BRADLEY FAIR 2ND ADDITION TO WICHITA, SEDGWICK COUNTY, KANSAS

RE: S/D 95-78 - Revision to Final Plat of the BRADLEY FAIR 2ND ADDITION

RE: S/D 95-78 - Final Plat of the BRADLEY FAIR 2ND ADDITION

CASE NUMBER: S/D 95-78 BRADLEY FAIR 2ND ADDITION

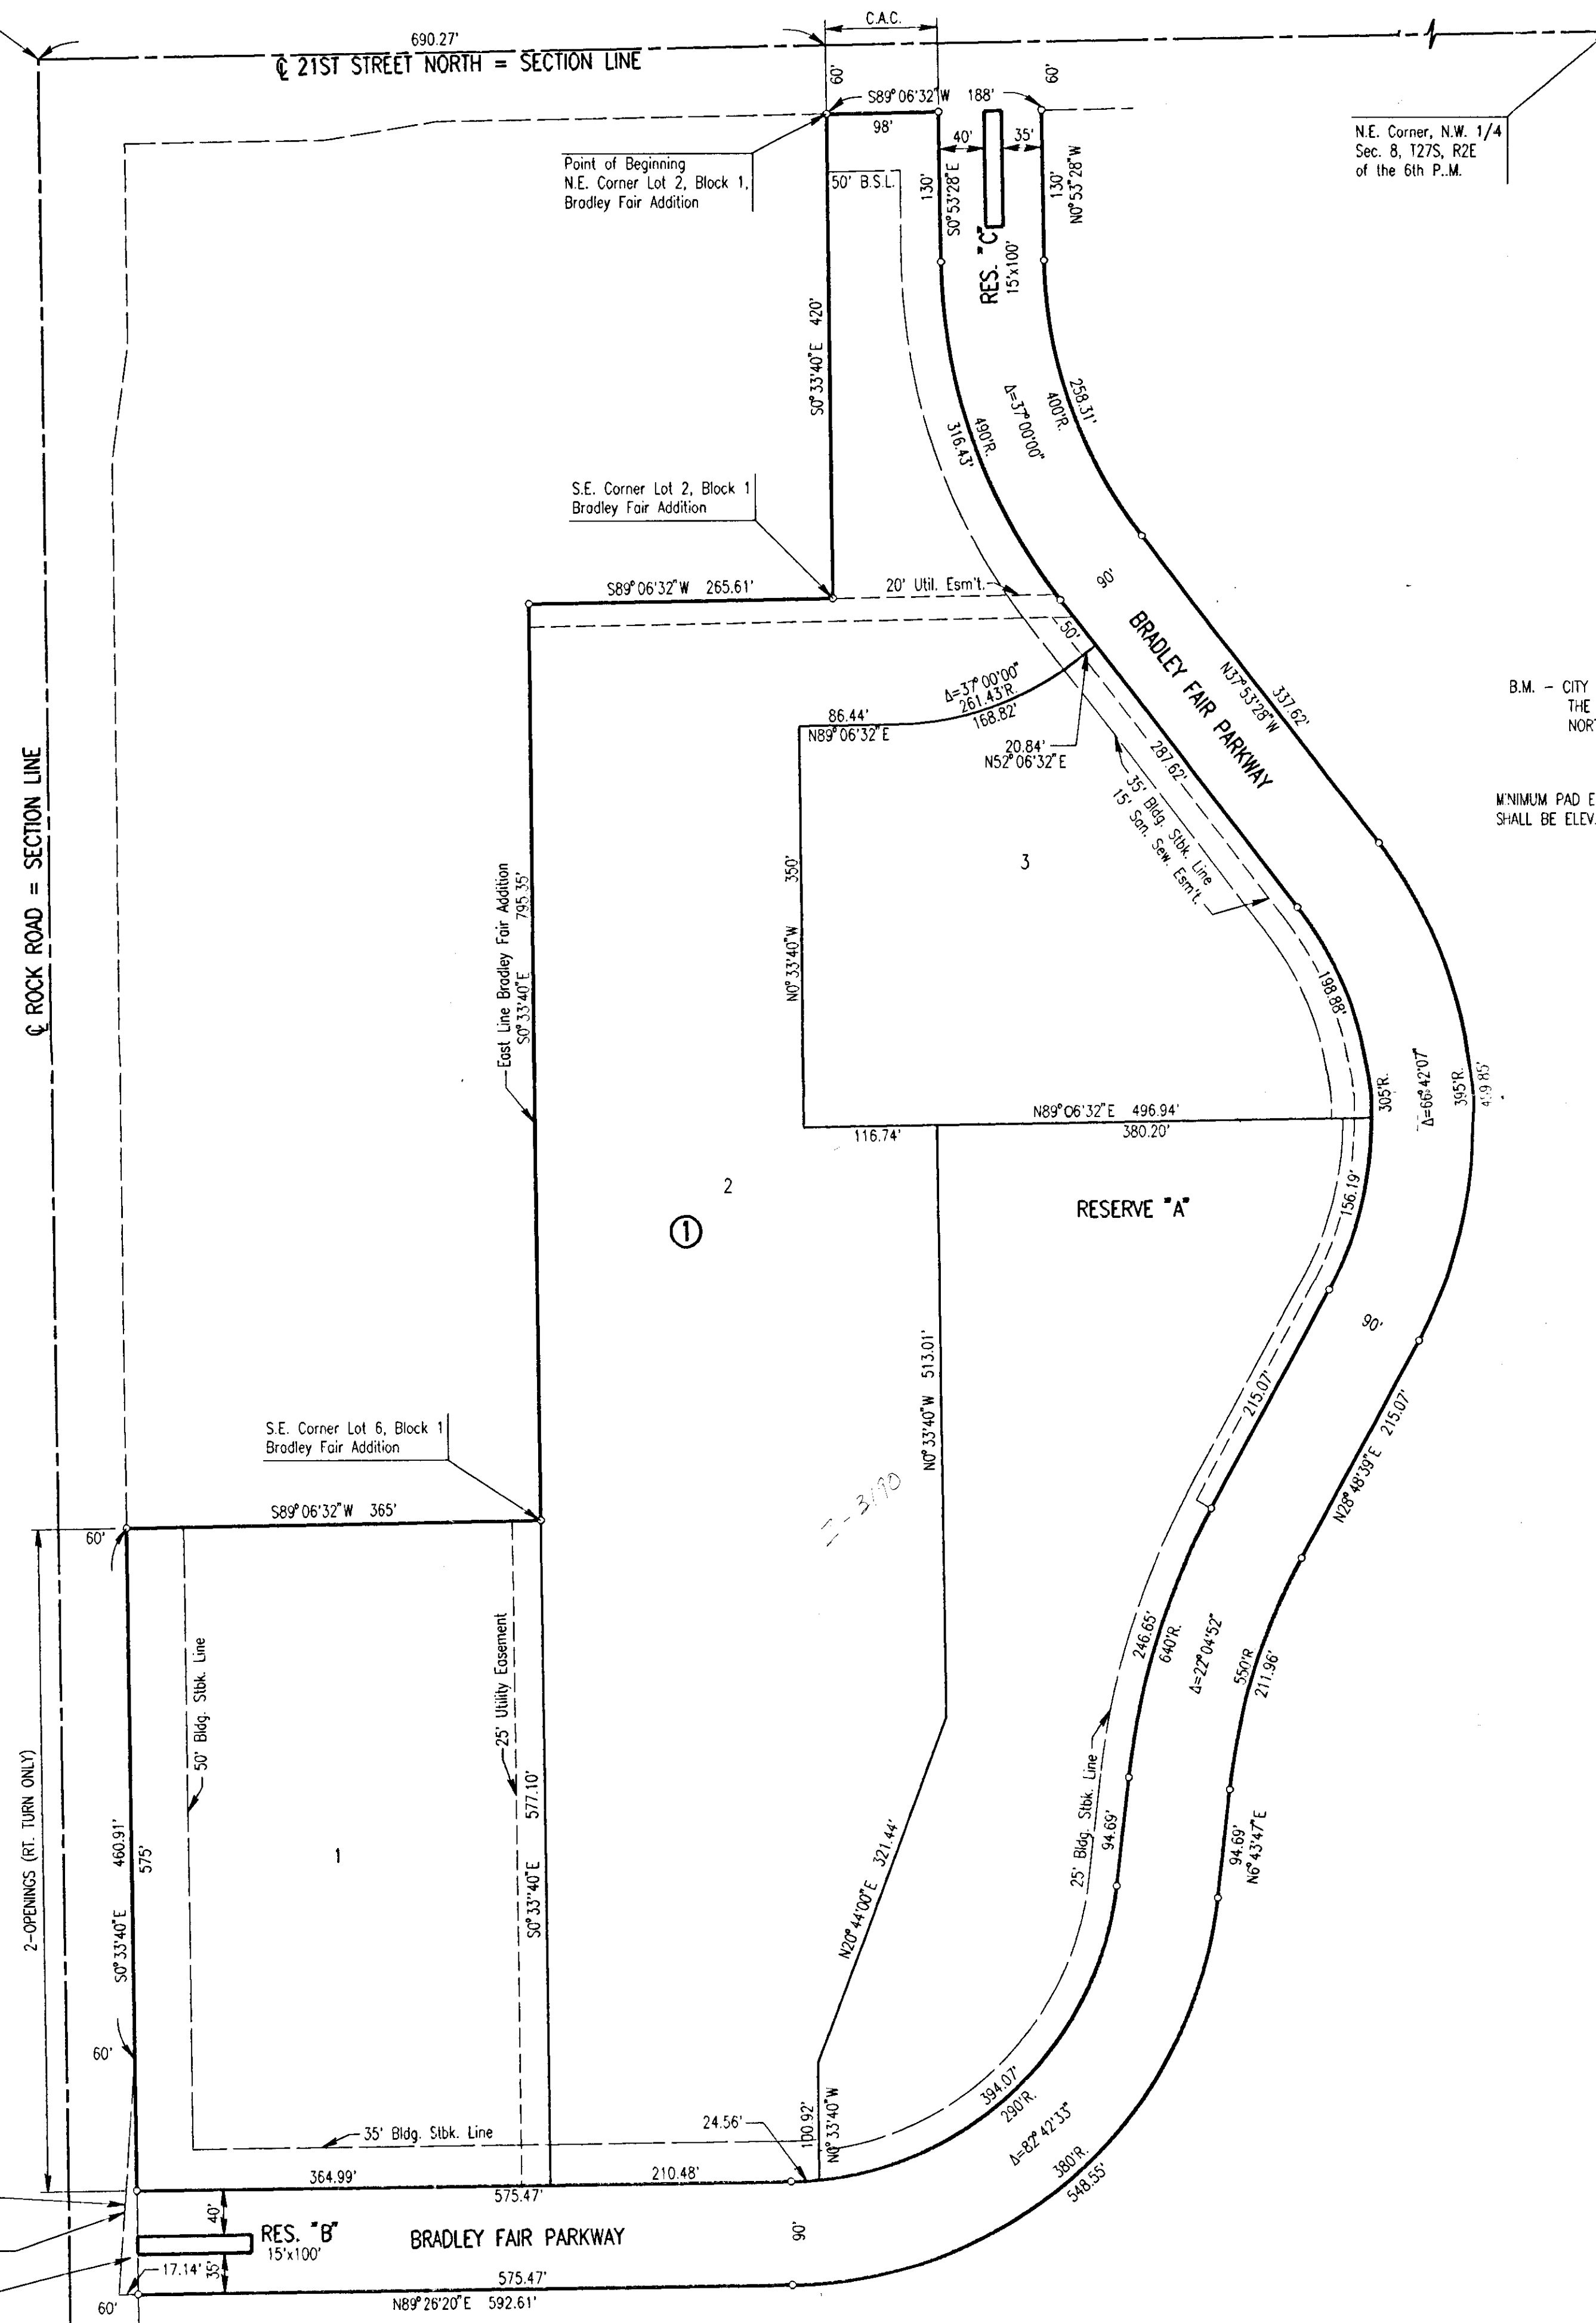
At the March 28, 1996 meeting of the Metropolitan Area Planning Commission (MAPC), your request to revise the above referenced plat was considered. The MAPC agreed that the Reserve area as originally platted within Bradley Fair Parkway's right-of-way could be revised as requested and shown on your revised plat. Except as necessary to reflect the above change, all conditions of approval as noted in the letter of January 18, 1996 are still in effect.

*3/25/96 - see revised copy
of the final plat - MHA, IC
approved & elimination of
median / Reserve within Bradley
Fair Parkway.*
